25315 - BESD TREMONTON ELEMENTARY
2900 West 500 North Tremonton, UT

Addendum **ADD-003.0**

ADDENDUM 003

G112

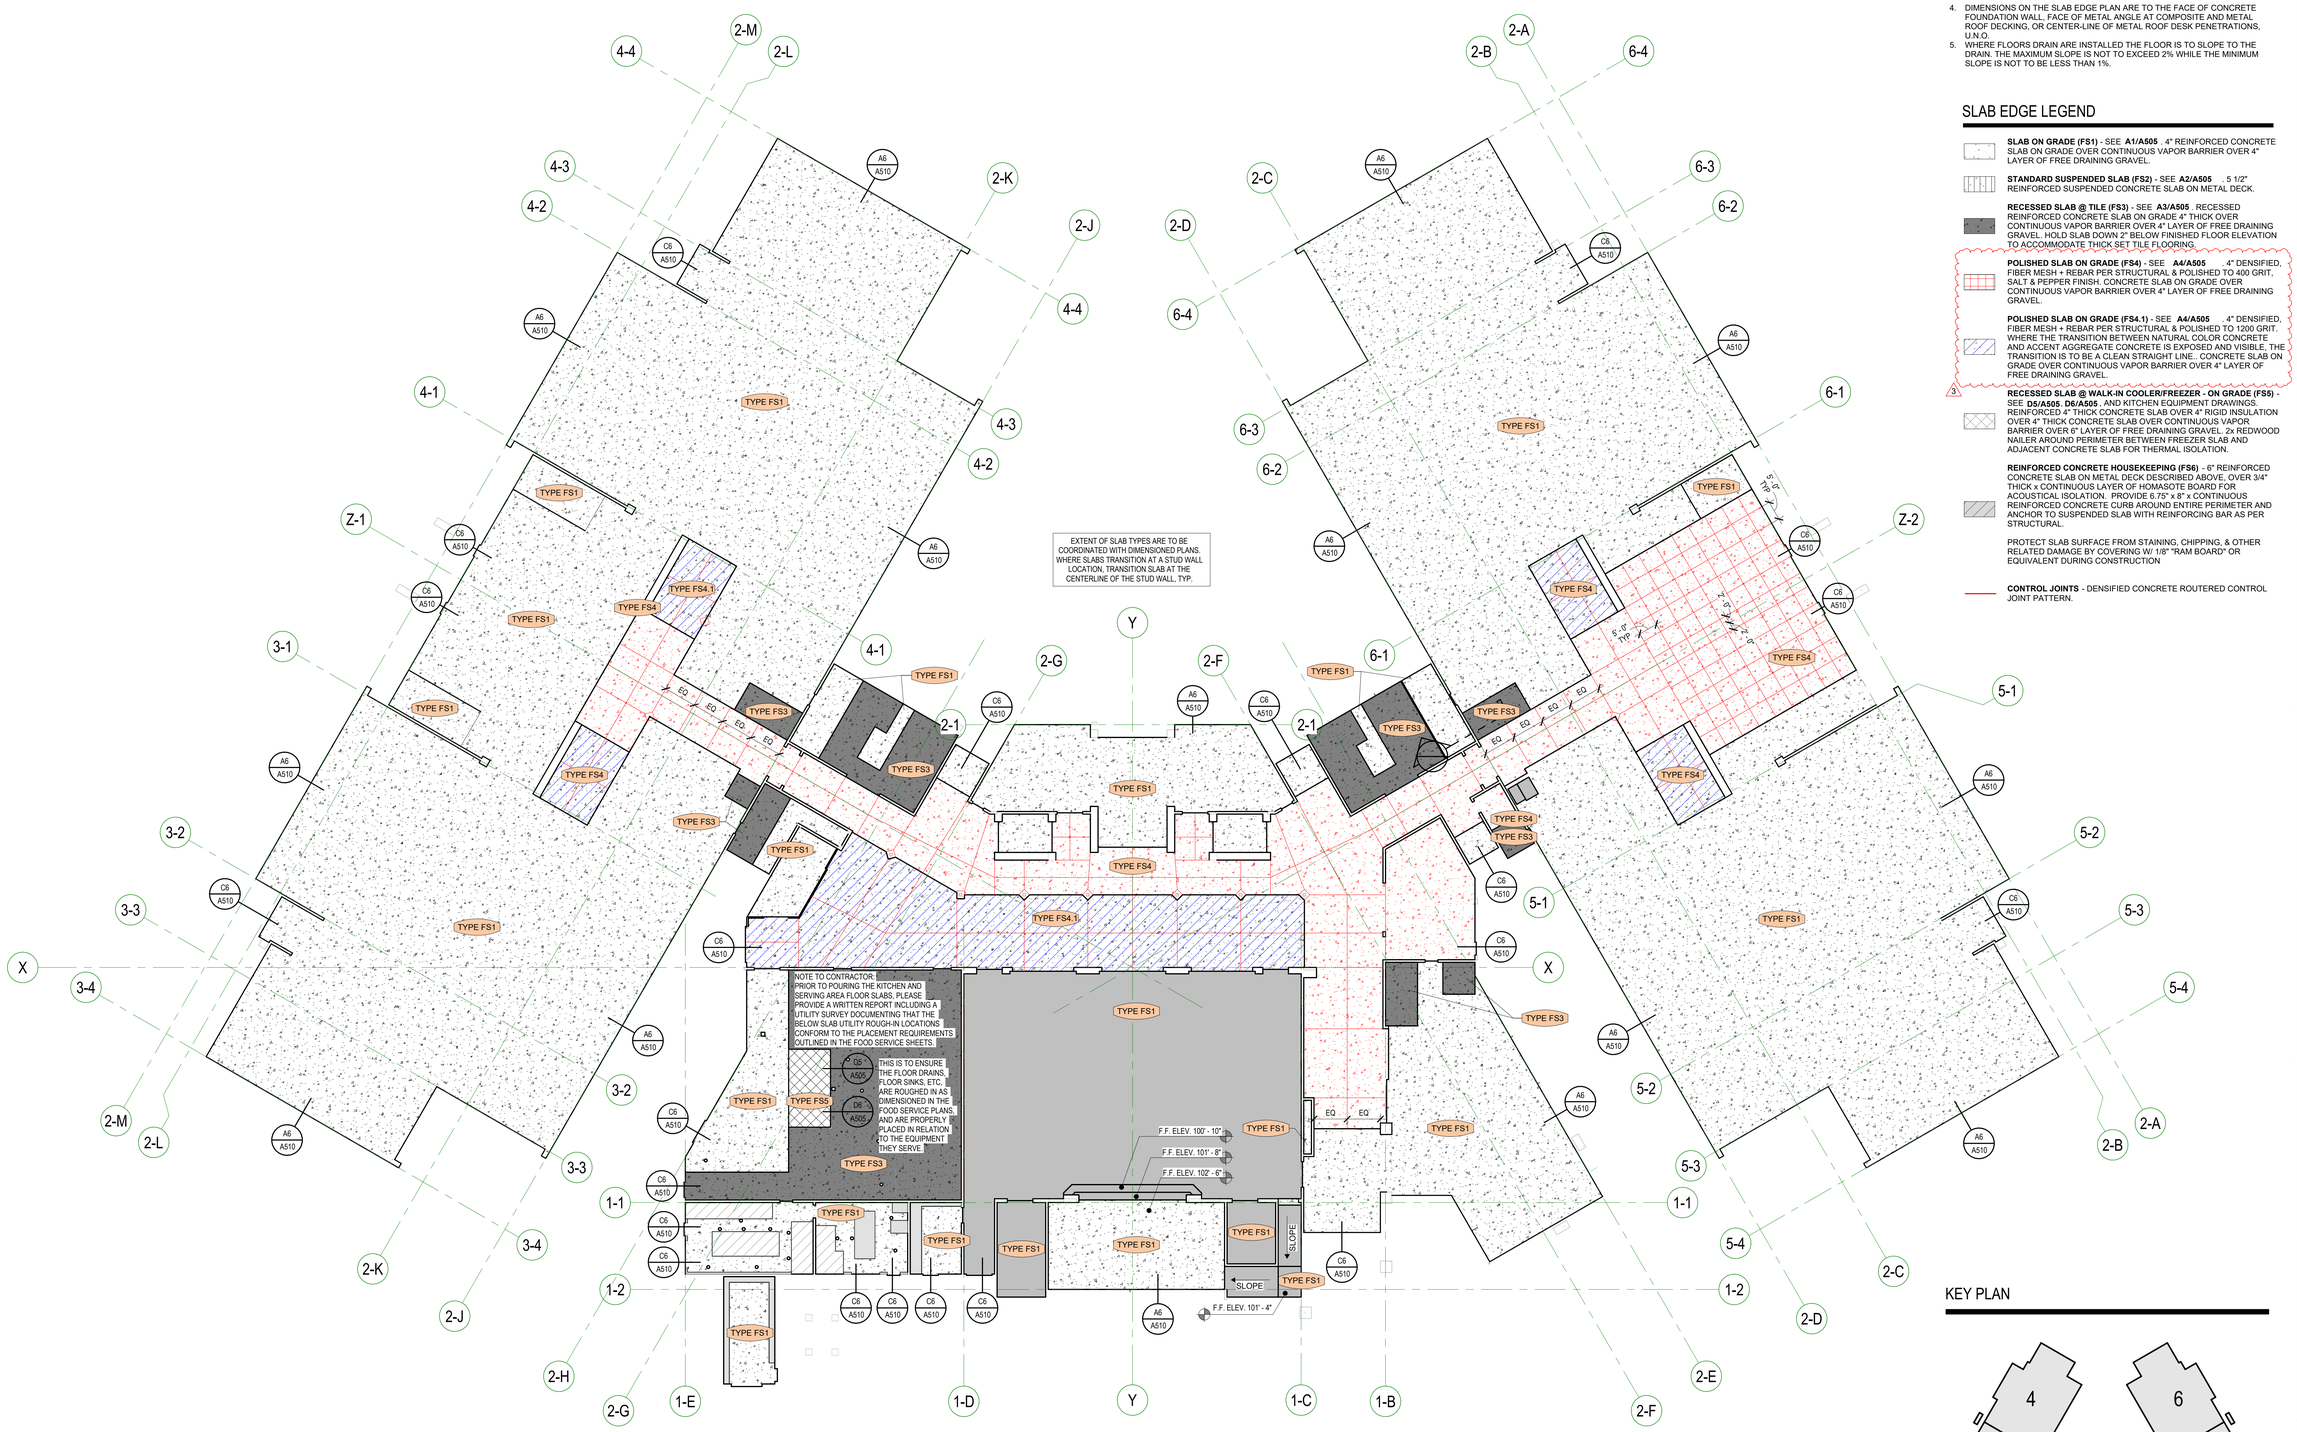
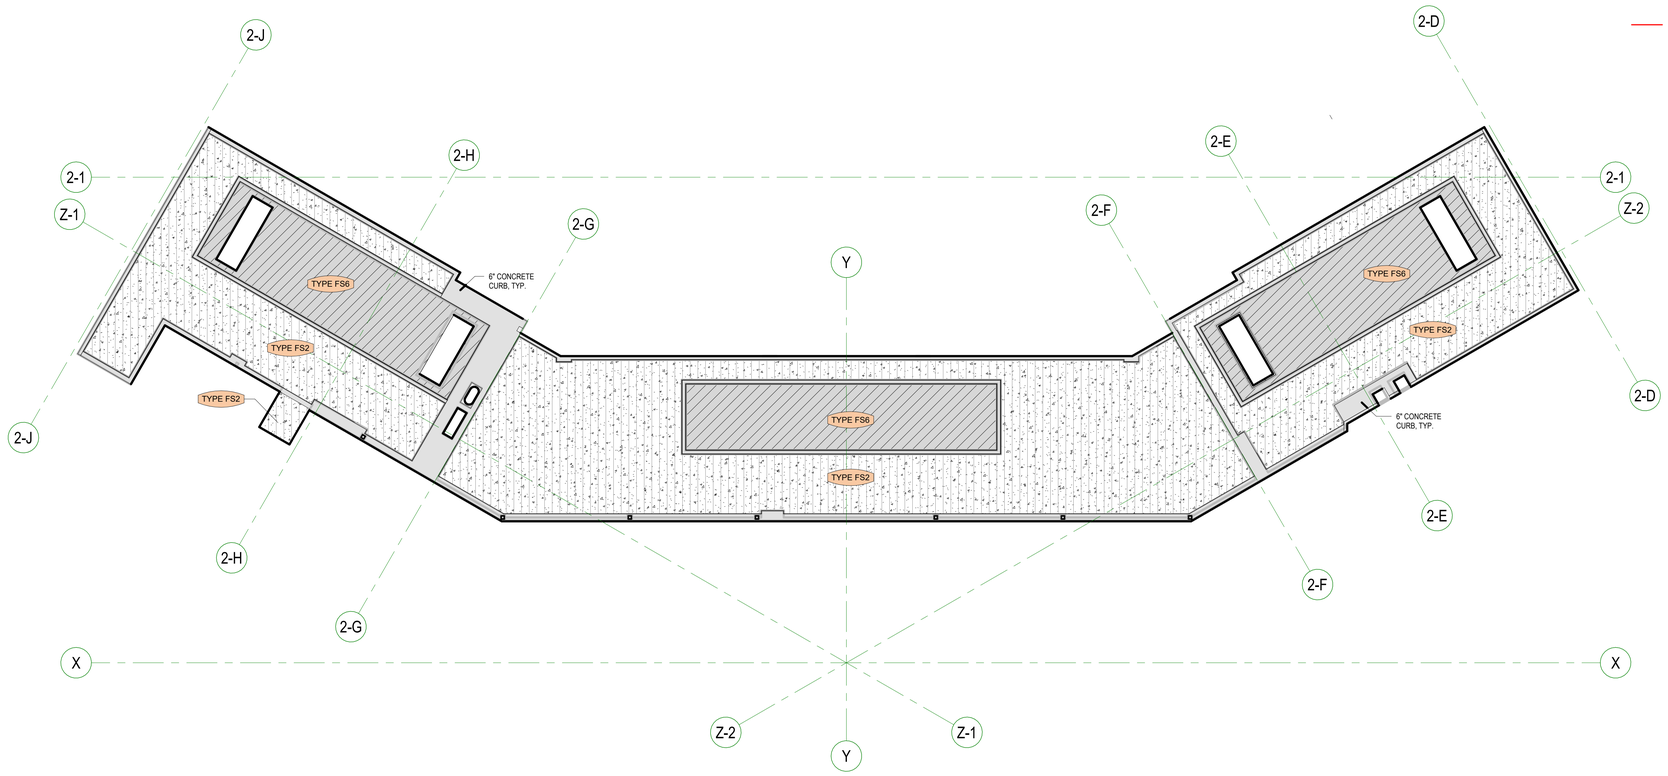
- Sheets G111 & G112 – Change Slab Edge Legend per the attached sheets.
- Sheet AS101 – Updated east property line mow strip & curb/gutter. Updated ADA Access points. Removed truncated dome panel @ bus loop. Added & Updated keynotes, per attached sheet

AS103

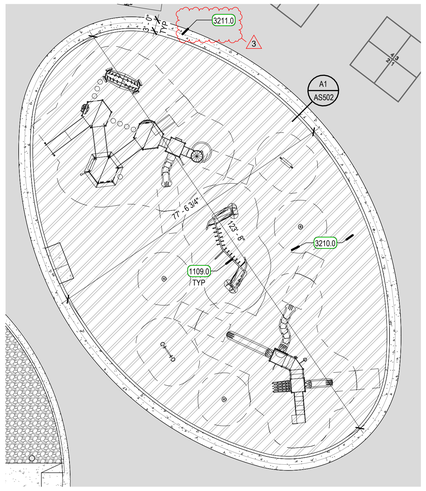
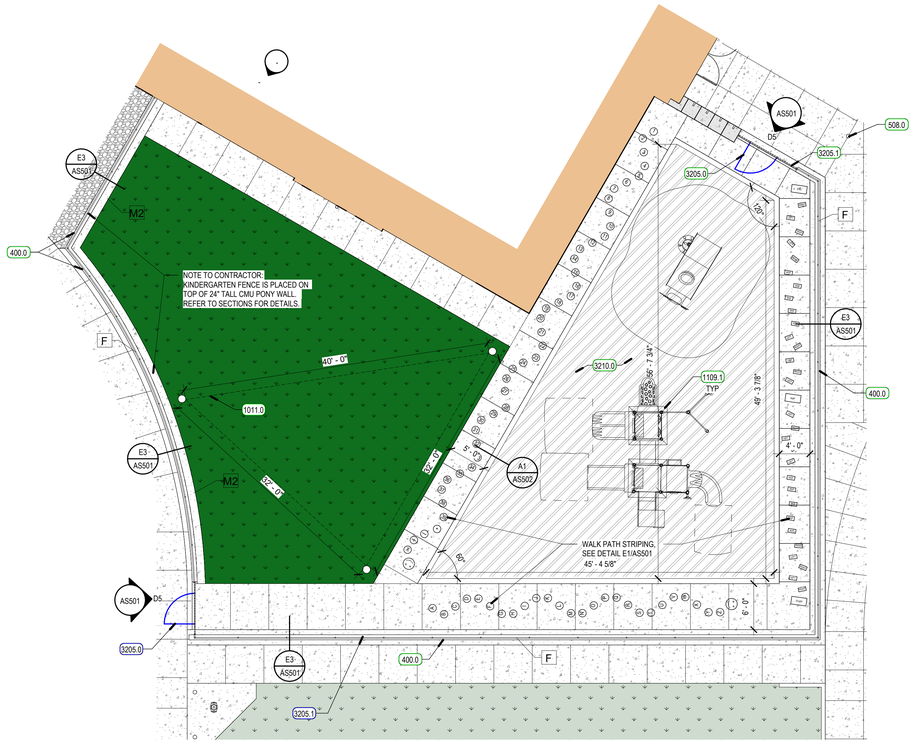
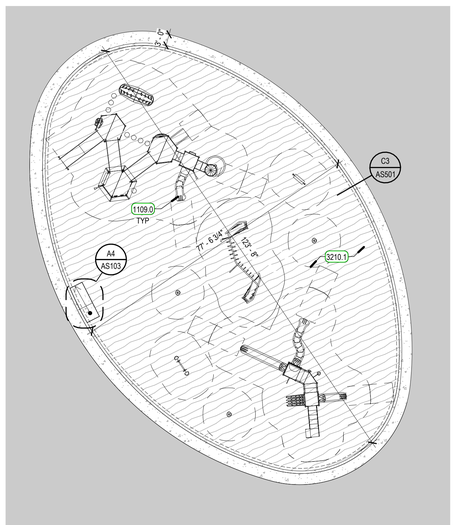
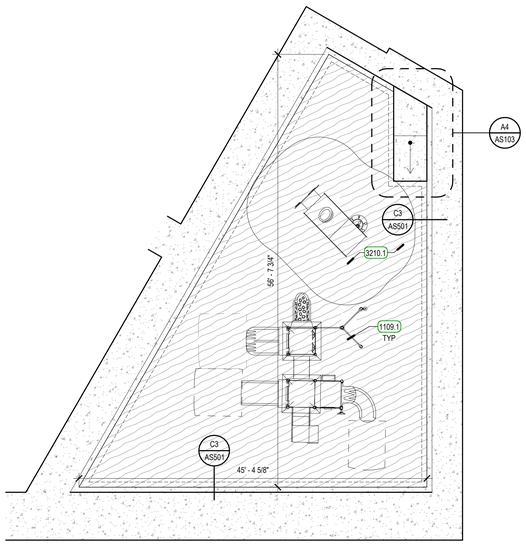
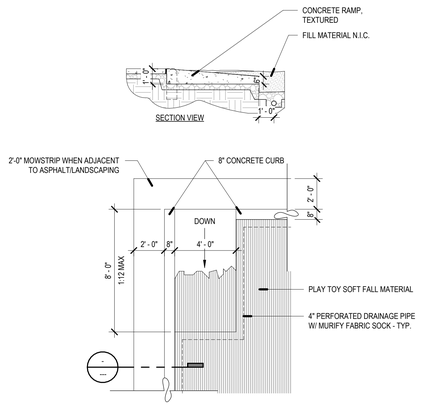
- Sheet AS103 – Detail C1 – Added keynote, per attached sheet
- Sheet A111.1 – Removed keynote specifying densified concrete slab & polish.
- Sheets A111.2, A112.2, A113.2, A114.2, A115.2, A116.2 – Corrected all wall types labeled AC8 to wall type 4C8.

A351

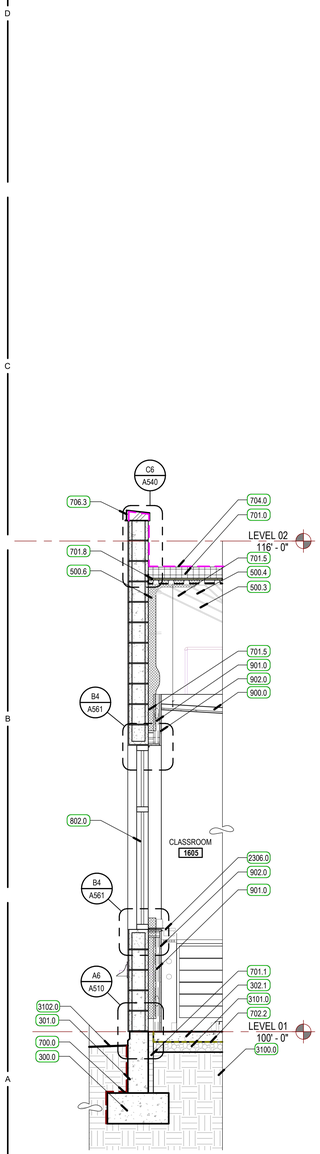
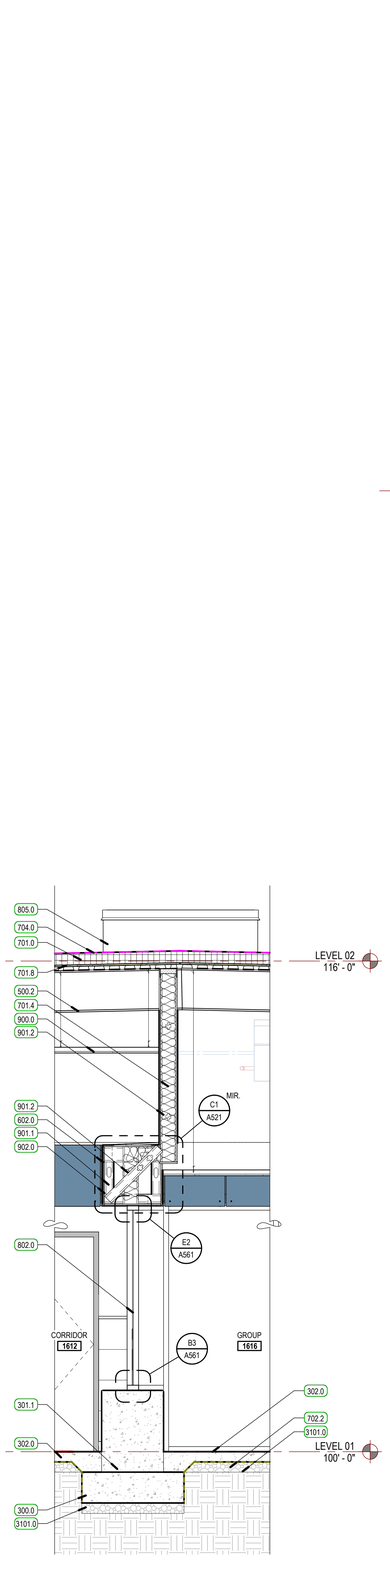
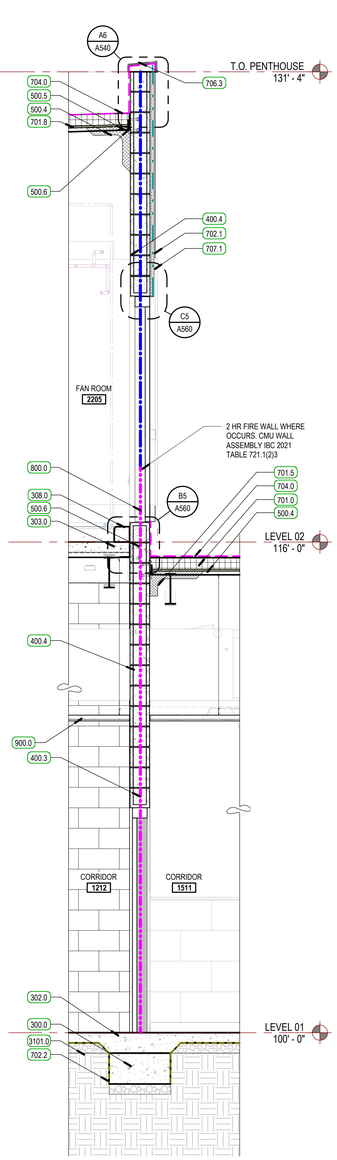
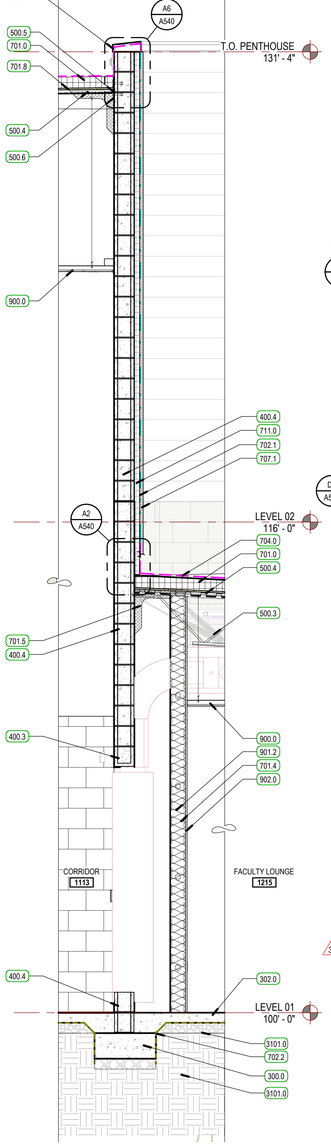
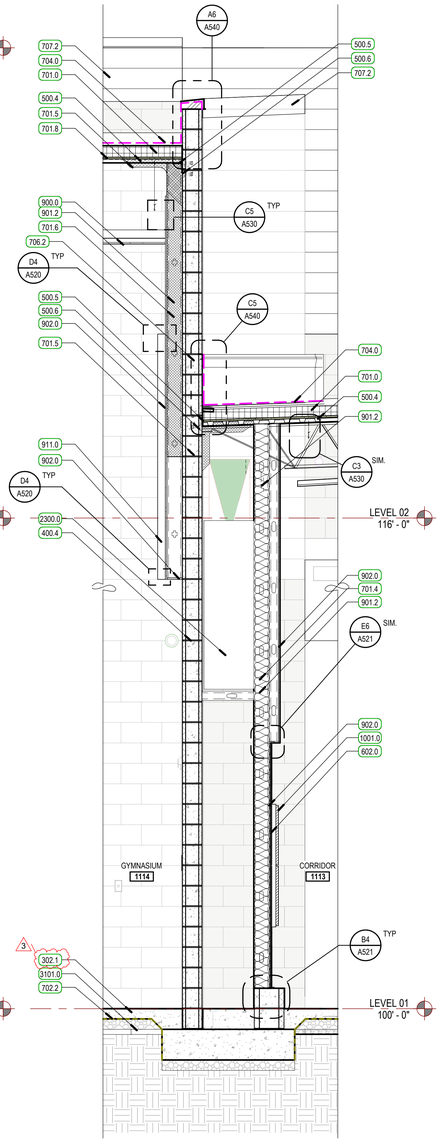
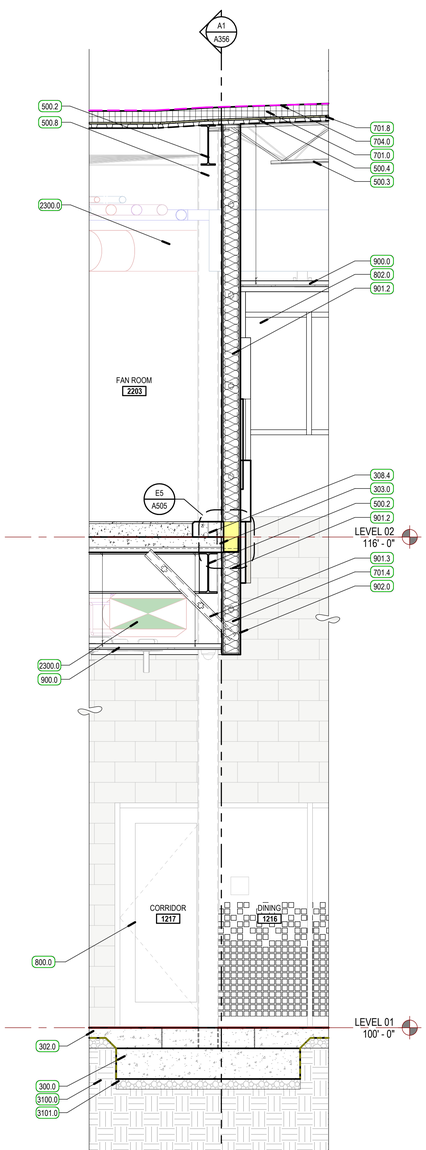
- Sheet A114.1 – Added keynotes, per attached sheet.
- Sheets A351, A352, A354 – Updated Gymnasium concrete flooring keynote, per attached sheet.
- Sheet A400 – Updated exterior masonry color/mfr.

A401

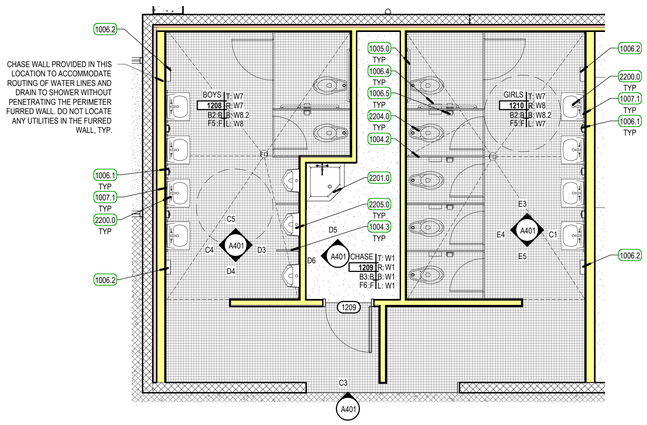
- Sheet A401 – Added sanitary napkin disposal units to Staff and Admin toilet rooms
- Sheets A403, A404, A405, A406 – Located & dimensioned whiteboards, tack boards, and TV/Monitors. Adjusted location of some of these elements on details A404/C3 & A405/A1 to be consistent with other locations
